(12) United States Design Patent (10) Patent No.:

(54)	CLOSURE					
(75)	Inventor:	Rodney Malcolm Druitt, Warwickshire (GB)				
(73)	Assignee:	Owens-Illinois Closure Inc., Toledo, OH (US)				
(**)	Term:	14 Years				
(21)	Appl. No.: 29/153,552					
(22)	Filed:	Jan. 11, 2002				
Related U.S. Application Data						
(62)	Division of application No. 29/132,510, filed on Nov. 13, 2000.					
(30)	Foreign Application Priority Data					
May 12, 2000 (AU)						
` /	, ,	Cl 09-07				
(52)	U.S. Cl.					
(58)	Field of Se	earch				
	D9/45	3, 438; 215/235, 250, 257, 258; 220/200,

It is certified that error appears in the above-identified patent and that said Letters Patent is hereby corrected as shown below:

FIG. 2

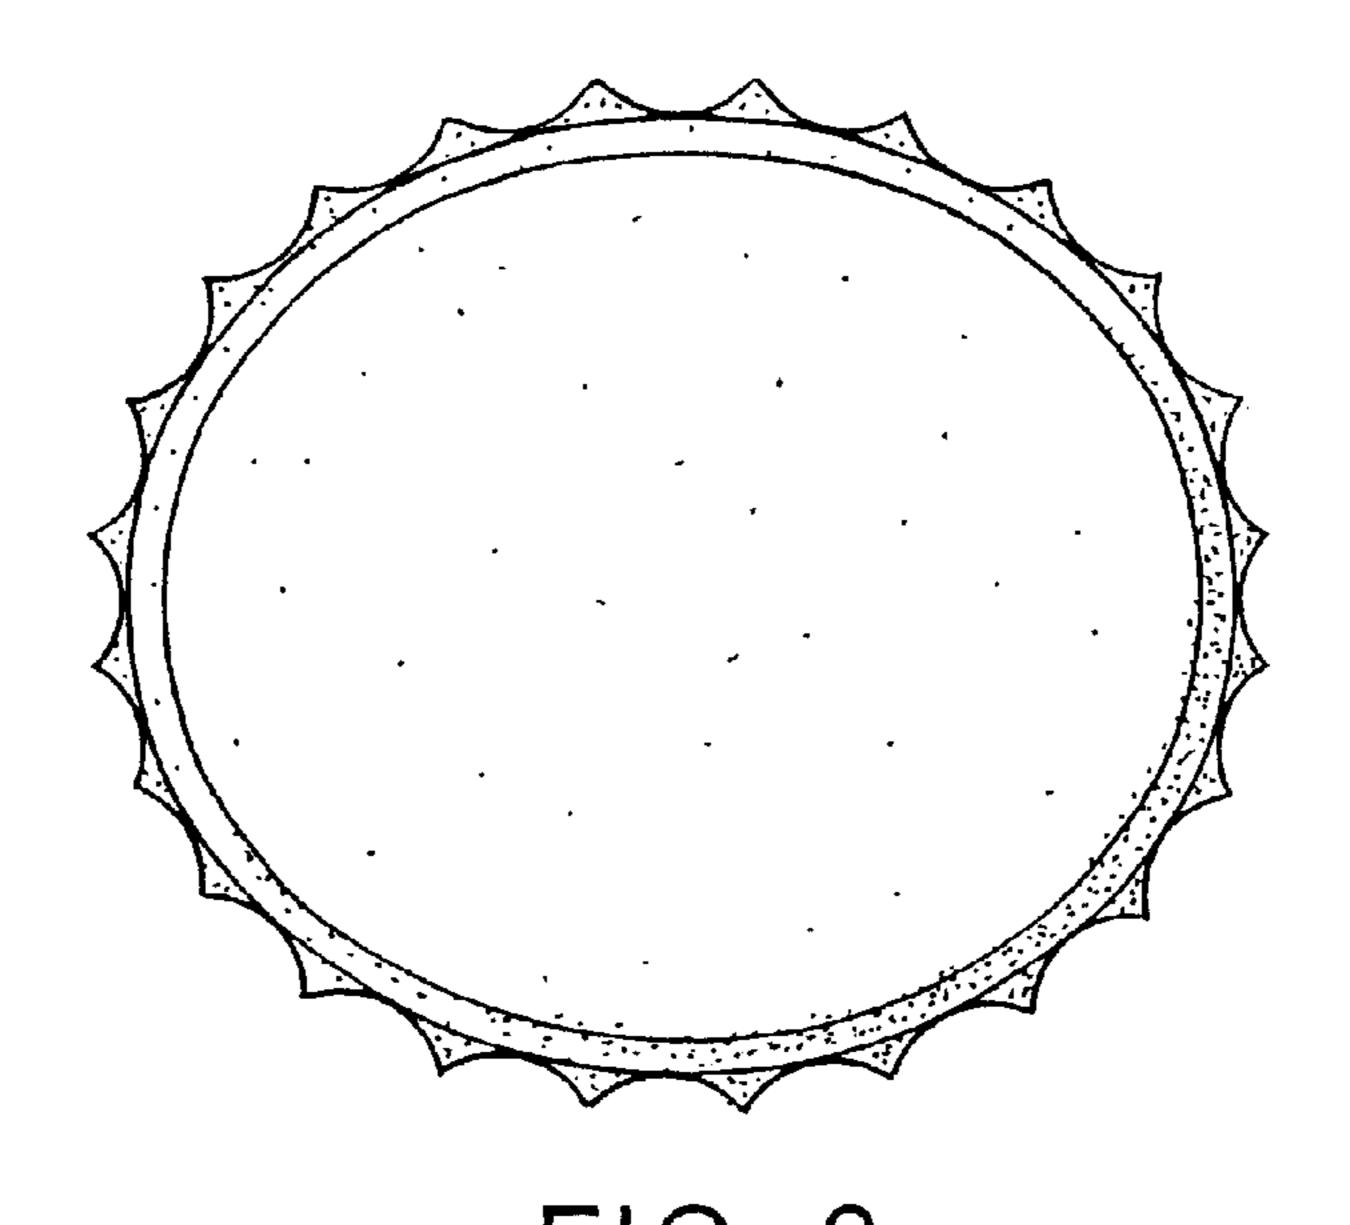
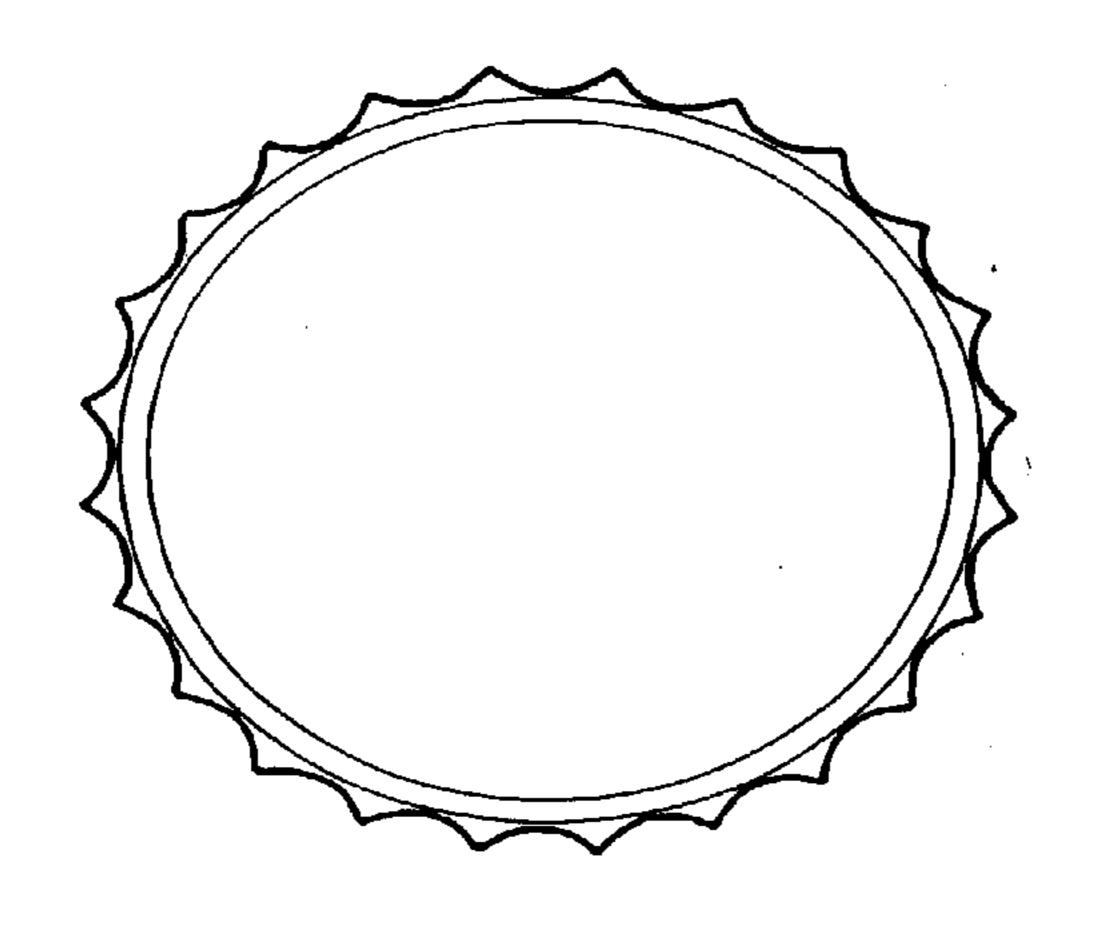
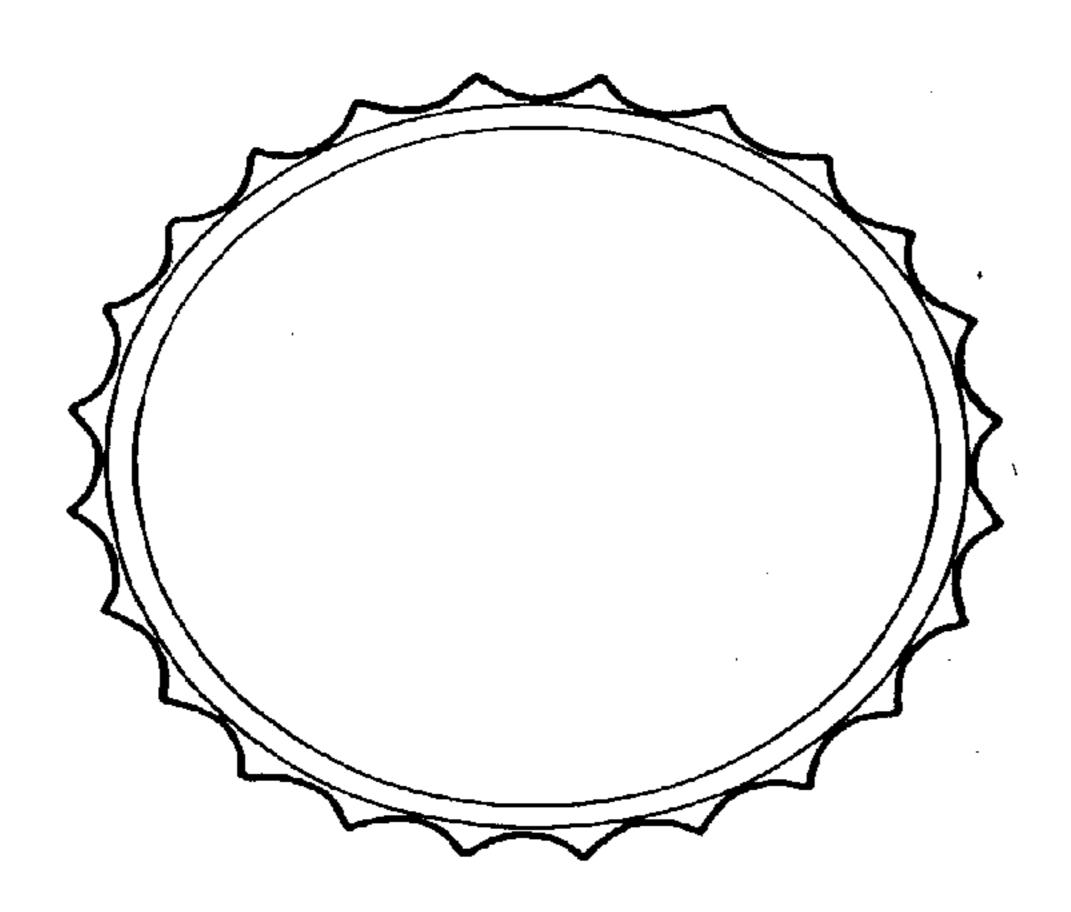
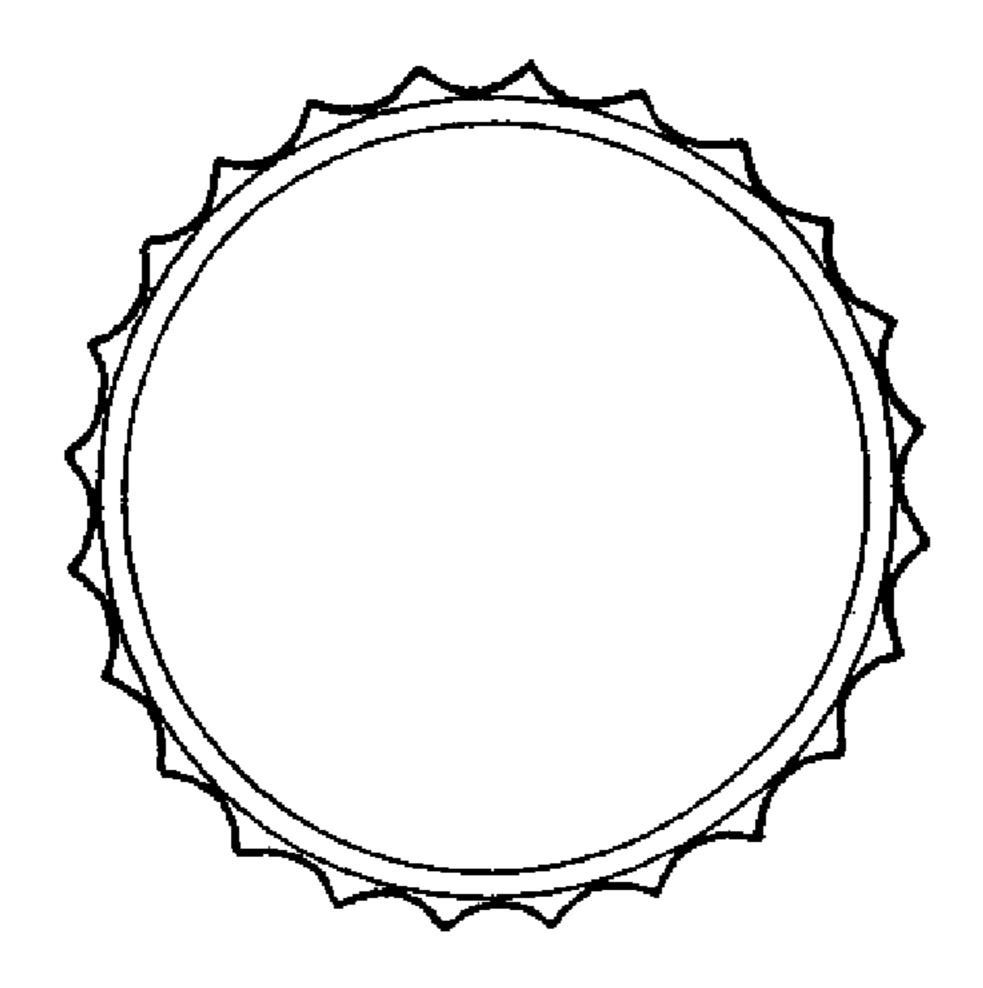
Figures 2, 5, 7 and 10 should be as attached.

Figures 2 and 5, should be as below.

Figures 2 and 5, should be as below.

FIG. 10

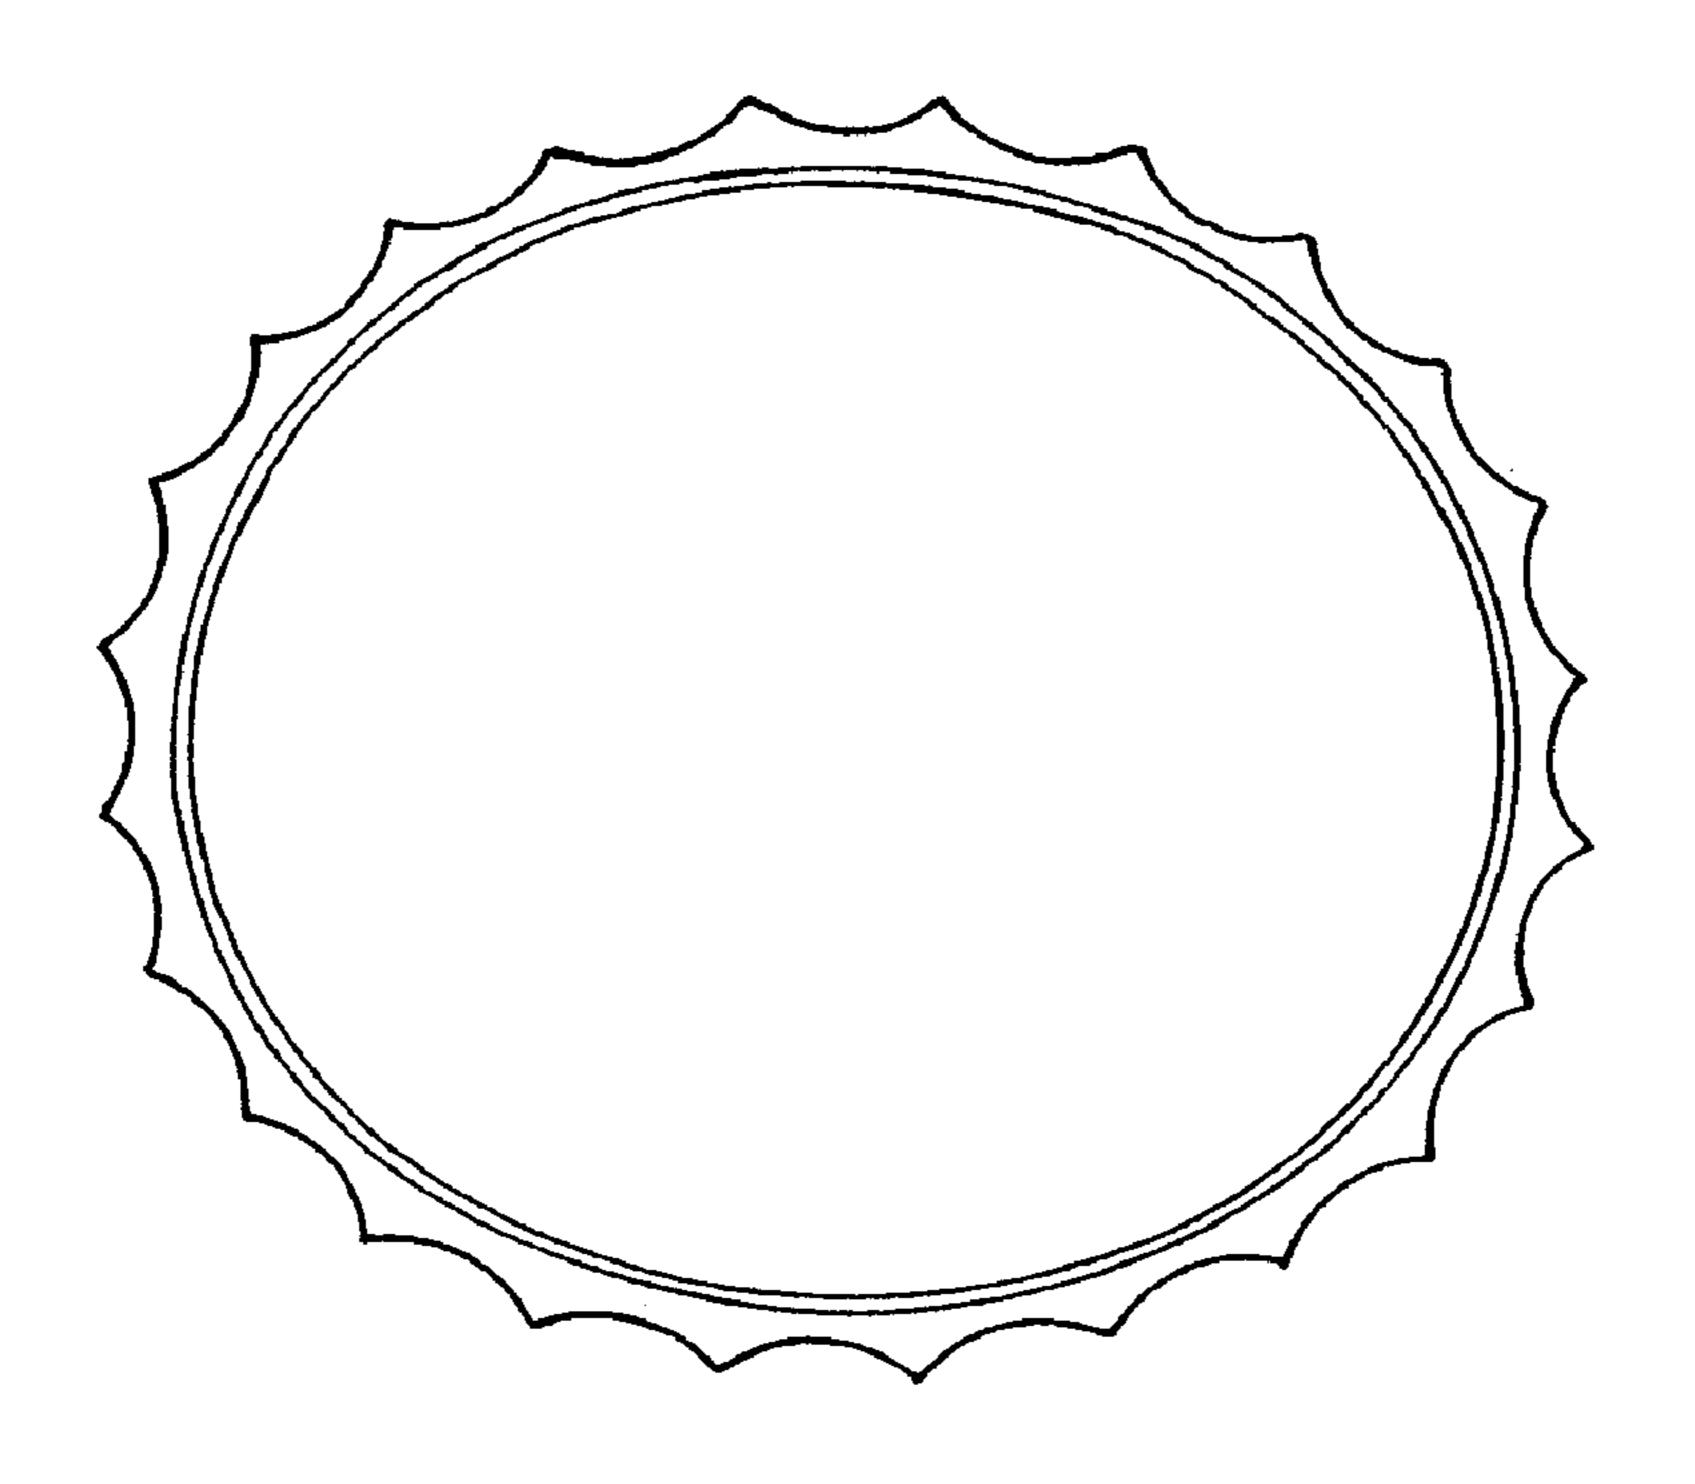
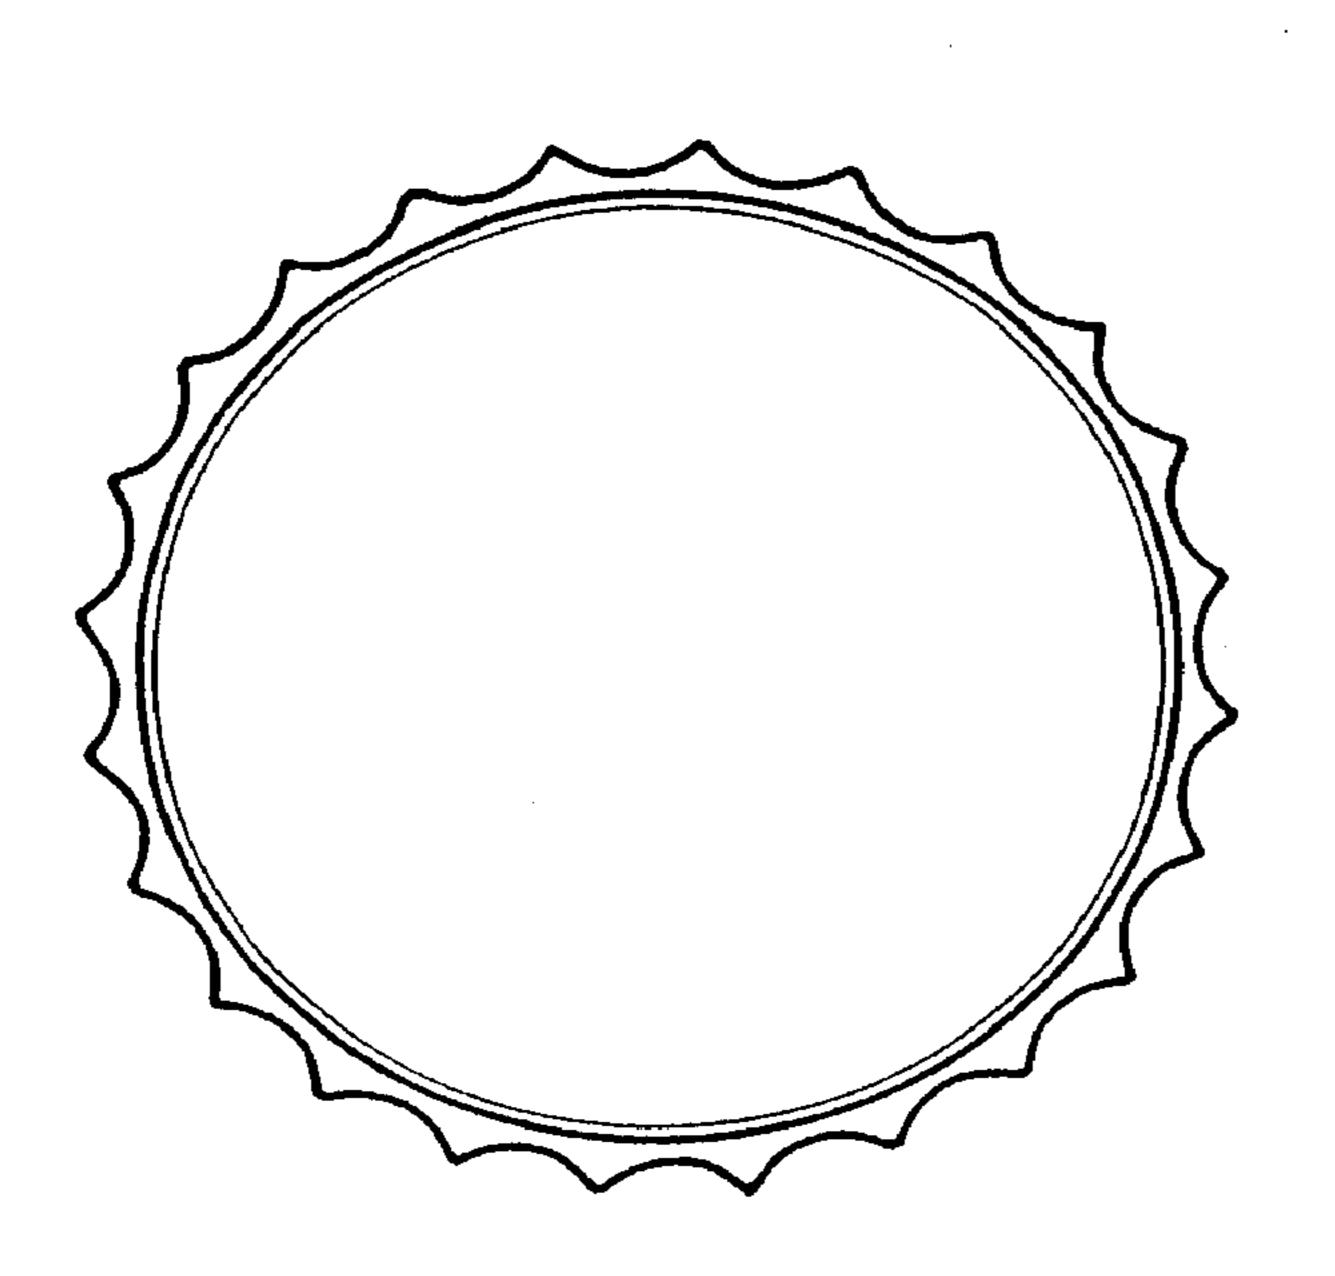
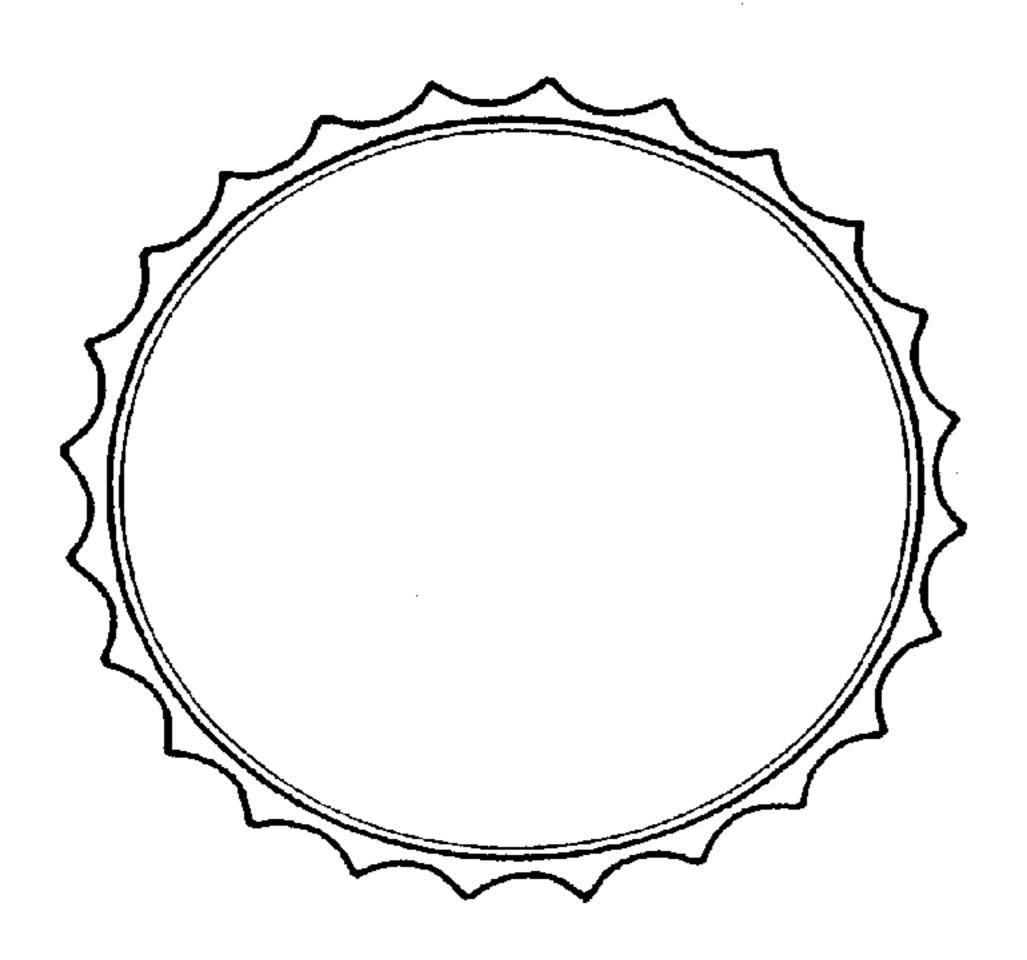
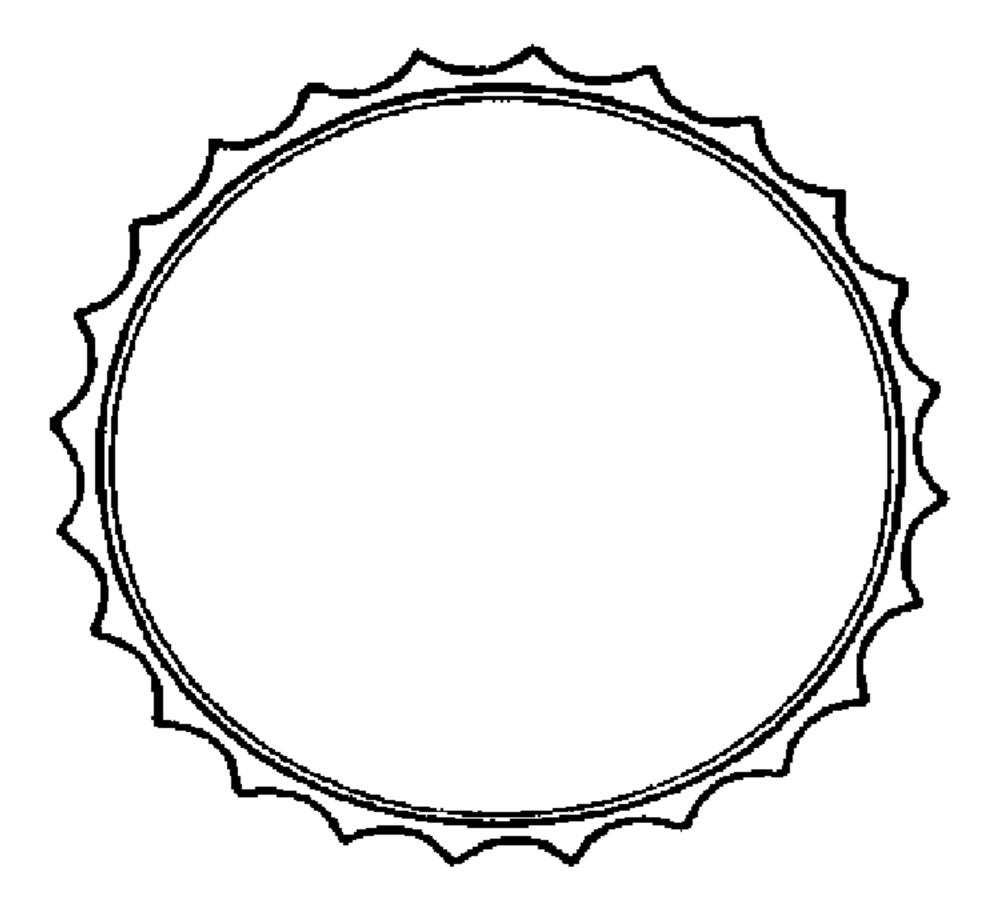
Figure 10, should be as below.

Figure 10, should be as below.
